MFN 07-186

Docket No. 52-010

Subject: **Response to Portion of NRC Request for Additional Information Letter
No. 74- Auxiliary Systems – RAI Numbers 9.3-33 through 9.3-35**

**Response to Portion of NRC Request for
Additional Information Letter No. 74
Related to ESBWR Design Certification Application**

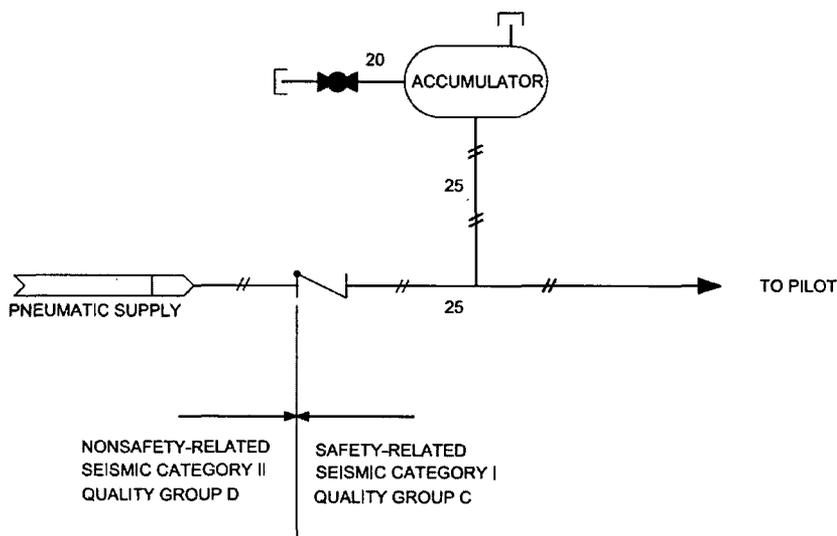
DCD Section 9.3 states that the accumulators and valves associated with the main steam isolation, automatic depressurization, and isolation condenser isolation valves are part of the respective systems. However, the DCD sections describing those systems do not include drawings or detailed descriptions regarding the safety-related pressurized gas supplies for operation of those valves.

Provide diagrams of safety-related pressurized gas supplies, including separation from the normal nonsafety-related supply of pressurized gas, to all safety-related valve operators, including the following valves: main steam isolation, automatic depressurization, and isolation condenser isolation valves.

Clarify the classification of valves, piping, and pressure vessels that provide the pneumatic pressure essential to operation of safety-related valves. DCD Section 9.3 states that the accumulators and valves associated with the main steam isolation, automatic depressurization, and isolation condenser isolation valves are part of the respective systems. However, the DCD sections describing those systems do not include drawings or detailed descriptions regarding the safety-related pressurized gas supplies for operation of those valves. Clarify the classification of valves, piping, and pressure vessels that provide the pneumatic pressure essential to operation of the following safety-related valves: main steam isolation, automatic depressurization, and isolation condenser isolation valves.

Describe how the piping, valves and pressure vessels that provide the essential pneumatic pressure for operation of safety-related valves are protected against dynamic effects associated with design basis accidents such that, concurrent with a postulated single active failure, the necessary number of safety-related valves actuate to the correct position.

A representative schematic of accumulators that supply air or nitrogen to safety-related valves is shown below. Safety-related and nonsafety-related separation is at the accumulator check valve.

See schematic shown in RAI 9.3-33 response.

See the schematic in RAI 9.3-33 response. Protection against dynamic effects is provided in DCD Tier 2, Section 3.6. Single active failures are addressed through redundant modes of actuation. MSIV's will close by spring actuation and/or pneumatic actuation. SRV's are lifted open by pneumatic actuation or lifted by steam pressure at a prescribed setpoint. For ICS isolation valves, there are two pairs of valves inside containment one on the steam inlet and one on the condensate return lines; each valve within a pair has a different mode of actuation from the other valve. For instance, one valve shall be nitrogen rotary motor-operated and the other shall be nitrogen piston-operated.
